**72.48 Applicability Analysis for Changes, Tests, Experiments****Description of Activity:**

GE-MO License SNM-2500, Section 4.0, Paragraph 4.8.1 specifies basin water chemistry values for pH (4.5 to 9.0),  $\text{NaNO}_3$  (<200 ppm), and Cl (<10 ppm). This 72.48 provides evaluation of a proposed change in water conductivity value to 1.35 (equivalent 5.5 to 8.0 pH) and eliminate  $\text{NaNO}_3$  and Cl measurements.

TO: Morris Operation Safety Committee  
FROM: Christopher A. Roche  
DATE: July 28, 2004  
SUBJECT: **Justification for Updating Basin Chemistry Technical Specifications**

This report will propose changes to the Technical Specifications in section 4.8.1 of SNM-2500 and provide justification for the proposed parameters.

pH vs. Conductivity 1976 - Present

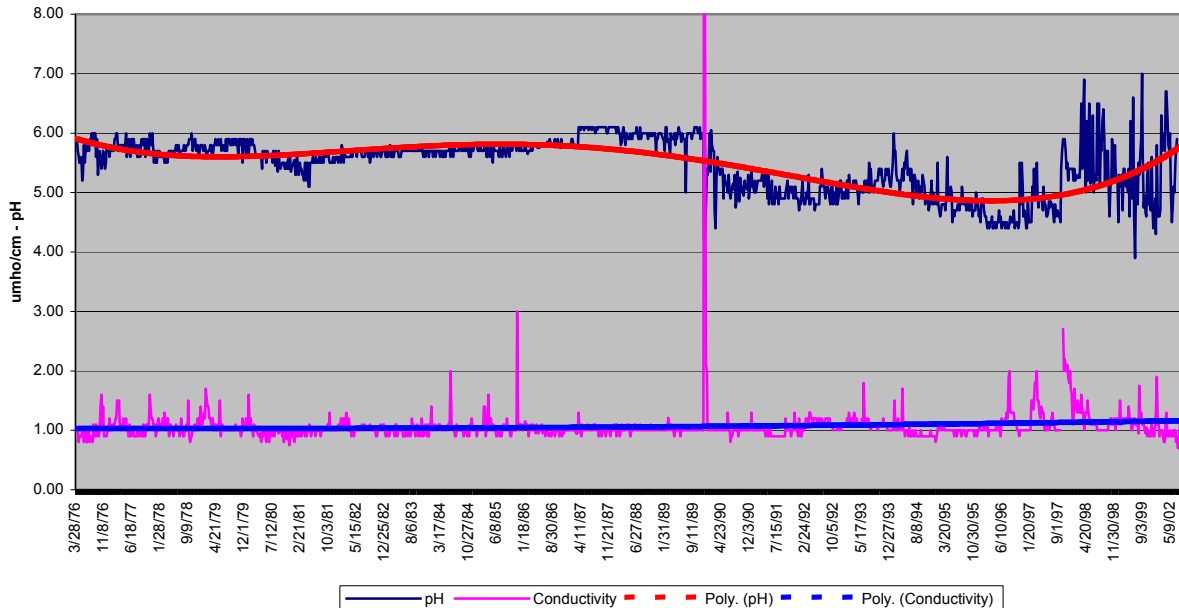
The above graph shows basin conductivity and pH since March 1976. Trend lines are imposed over the data to show data trends data over time. The conductivity has been very stable around 1.0  $\mu\text{mho/cm}$ . Conductivity spikes are attributable to basin operations that would be expected to raise conductivity, and actions were taken to quickly bring the parameters back to normal values. The pH values during the same period do not correlate with the conductivity values as would be expected for the very low conductivity of the basin water. Many of the pH values are outside of the possible pH range for the measured conductivity of the water. If the basin water conductivity is

maintained around 1  $\mu\text{mho/cm}$ , a measured pH below 5.5 is outside of the theoretical pH range and is most likely erroneous.

**pH-Conductivity Permissible Domain  
for NaCl System at 25 degC**

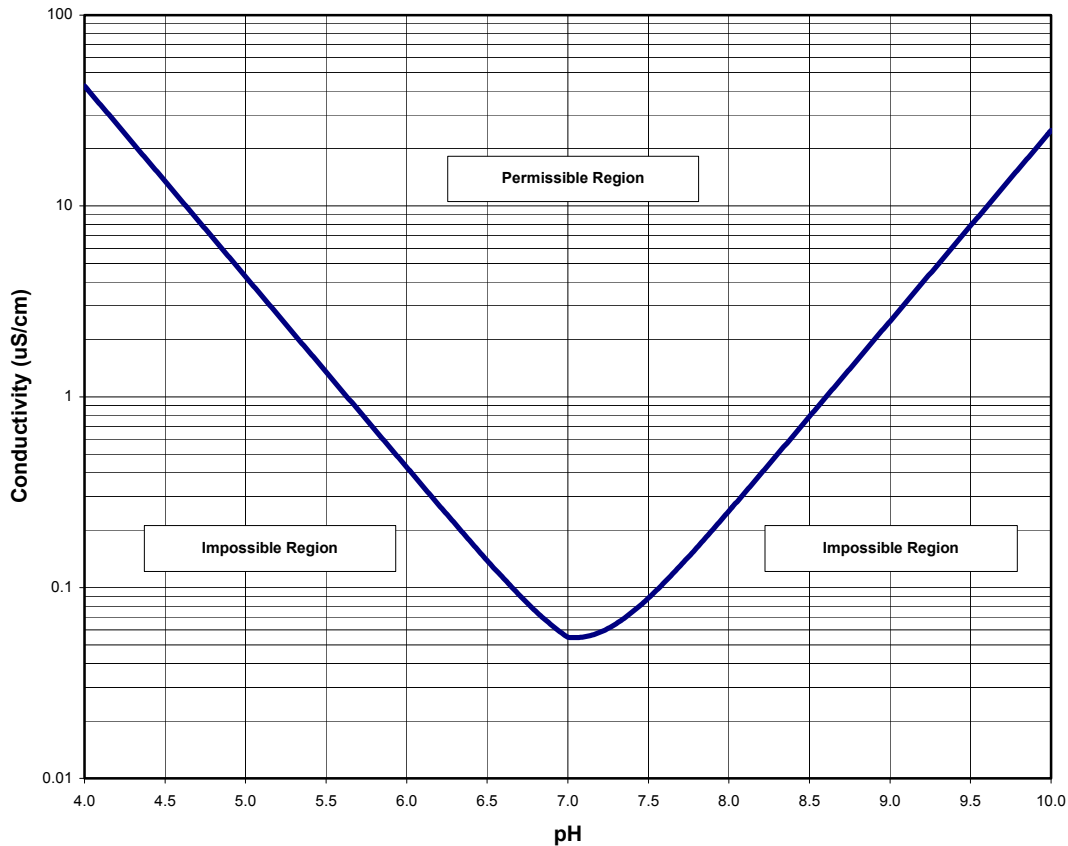
The following graph shows the permissible pH range for a given conductivity. A conductivity limit of 1.35  $\mu\text{mho/cm}$  would maintain the pH of the basin water between 5.50 and 8.73. This is more restrictive than the current specification of 4.50 to 9.00. The average conductivity of the basin water since March 1976 is 1.07  $\mu\text{mho/cm}$ . This conductivity has a pH range of 5.60 to 8.83.

1. Add a Conductivity specification of 1.35  $\mu\text{mho/cm}$  max.
2. Remove the pH,  $\text{Cl}^-$  and  $\text{NaNO}_3$  Technical Specifications.
